# UNITED STATES PATENT AND TRADEMARK OFFICE

APPLICATION NO.	FILING DATE	FIRST NAMED INVENTOR	ATTORNEY DOCKET NO.	CONFIRMATION NO.
10/659,552	09/10/2003	Anthony T. D'Amico	DAT104B	3096
32299	7590	07/26/2006	EXAMINER	
DENISE M GLASSMEYER YOUNG & BASILE, P.C. 3001 W. BIG BEAVER RD., SUITE 624 TROY, MI 48084-2813			BRANDT, ADAM CURTIS	
			ART UNIT	PAPER NUMBER
			3743

**Office Action Summary**

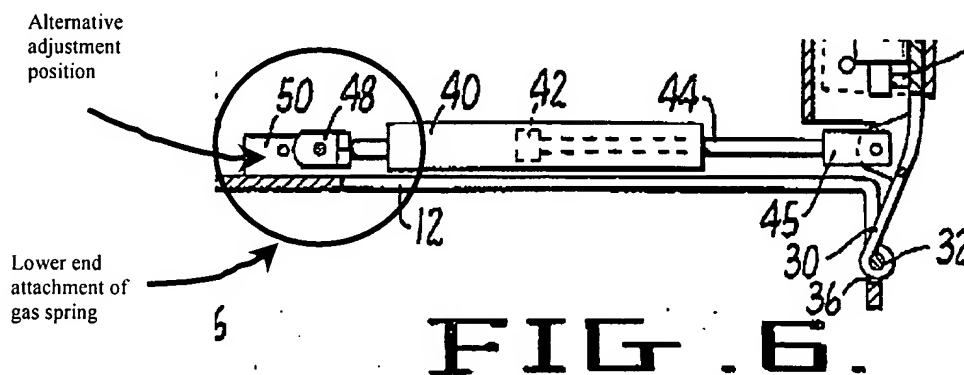
20. In regards to claim 17: Powlan discloses in figure 1 a body contacting assembly (cervical sling, figure 1) that releaseably contacts the patient. Figure 2 discloses a tractive force exerting apparatus capable of exerting force on the body contacting assembly containing a gas spring

member (40), an elongate member (26) adjustably attached to the lower end (see figure below) of the gas spring, a truss (12) having a first end region and a second end region located proximate to the elongate member, wherein the truss is in pivotal connection (32) with the elongate member and a tractive force transferring system including a tension line (28) having a first end and a second end. Although Powlan does not specifically recite that the elongated member is adjustably attached to a lower end of the gas spring, Powlan is considered to disclose an obvious mechanical equivalent for the following reason.

21. The elongate member (26) that is adjustably attached to the lower end of the gas spring: The gas spring (40) can be adjusted horizontally along the line of operation. A pin can be removed from terminal bar (48). The terminal bar can be aligned with the adjacent hole and the pin can be reinserted in the hole. Thus making the gas spring adjustable. Adjusting the gas spring at the upper or lower end is a considered to be an obvious design alternative because the alteration will uniformly affect the performance of the spring at either end.
